H. B. ROBINSON STEAM ELECTRIC PLANT

UNIT 2

INSERVICE INSPECTION PROGRAM

TECHNICAL EVALUATION REPORT

2. Page 5

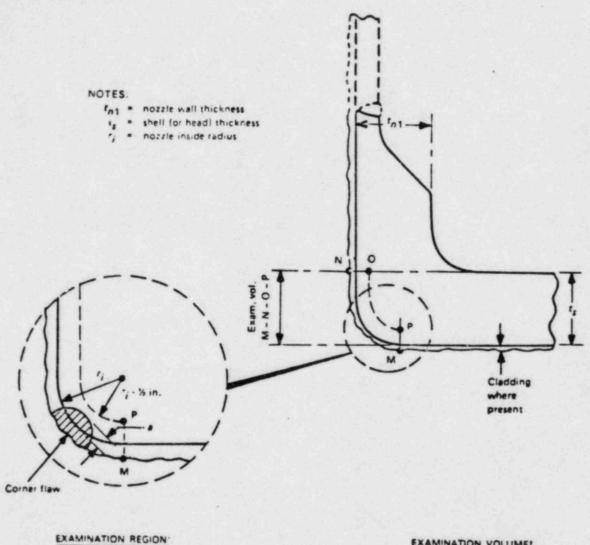
Category B-D in the 1977-S78 code specifically includes the nozzle inside radius section as an identified item to be examined on reactor vessel, pressurizer, steam generator and heat exchanger nozzles. Although category B-D is entitled full penetration welds of nozzles in vessels, the requirement to examine the nozzle inside radius section has been interpreted as applying to all nozzles including those that are integrally cast. The intent of the code was clarified in the Winter 1980 addenda by the inclusion of Figure IWB-2500-7(d) (attached) which specifically addresses examination of the inside radius section of integrally cast nozzles. The examination is included under category B-D in the 1980 code which is still titled "full penetration welds of nozzles in vessels". Even though the category B-D title identifies full penetration nozzle welds, the intent of the code has been interpreted to apply to the nozzle inner radius section of all nozzles.

The only additional information supplied by the licensee was a simplified drawing of the Pressurizer. This drawing provided little clarification beyond the drawing originally supplied in the plan. The evaluation included in the TER is valid based on the information available to the reviewer. Additional explanation by the licensee would be required before the TER could be revised.
